Access Compliance Report Public Rights-of-Way (Curb Ramps)

Main Street: VOLAR_ST Cross Street: RISILLA_ST Location: SE

ADA ID: RPRK211119133213 Ramp Type: Type 4 - Parallel Initial Pass/Fail: Fail Overall Compliance: No Severity Score: 19

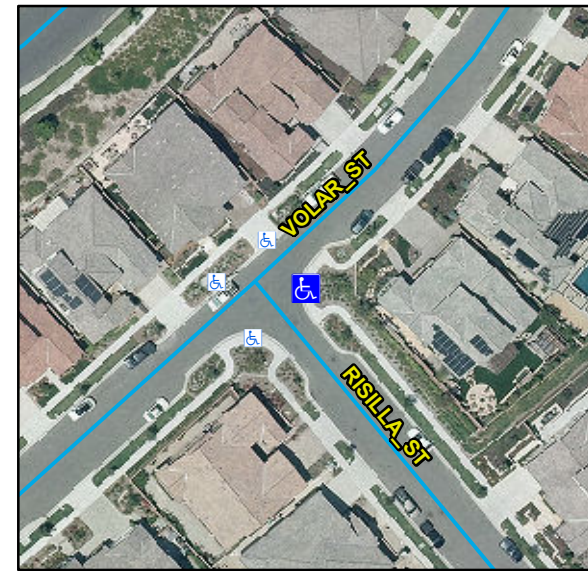
R304.5.1, R304.3.2, STD 1115

Compliance	Description	Data	Compliance	Description	Data
N/A	Ramp Length LT (in)	134	N/A	Ramp Length RT (in)	85
No	Ramp Width LT (in)	47	No	Ramp Width RT (in)	47
No	Ramp Run Slope LT (%)	9.3	Yes	Ramp Run Slope RT (%)	1.7
Yes	Ramp Cross Slope LT (%)	0.8	Yes	Ramp Cross Slope RT (%)	0.9
N/A	Landing Present	N/A	N/A	DWS Provided	N/A
N/A	Landing Length (in)	N/A	N/A	DWS Contrast	N/A
N/A	Landing Width (in)	N/A	N/A	DWS Length (in)	N/A
N/A	Landing Run Slope (%)	N/A	N/A	DWS Full Width	N/A
N/A	Landing Cross Slope (%)	N/A		DWS Offset Type	N/A
N/A	Landing Movement Obstructed?	N/A	N/A	DWS Offset Left (in)	N/A
	Landing Movement Type	N/A	N/A	DWS Offset Right (in)	N/A
N/A	Landing Shared	N/A			
N/A	Clear Space	Yes			
N/A	Clear Space To Crosswalk (in)	N/A			
N/A	Marked Crosswalk 1	No	N/A	Marked Crosswalk 2	No
	Crossing 1 Direction	N		Crossing 2 Direction	S
	Marked Crosswalk 1 Width (in)	N/A		Marked Crosswalk 2 Width (in)	N/A
N/A	Ramp Inside Crosswalk 1	N/A	N/A	Ramp Inside Crosswalk 2	N/A

Remove & Replace Curb Ramp With Two New Directional Ramps or Equivalent.
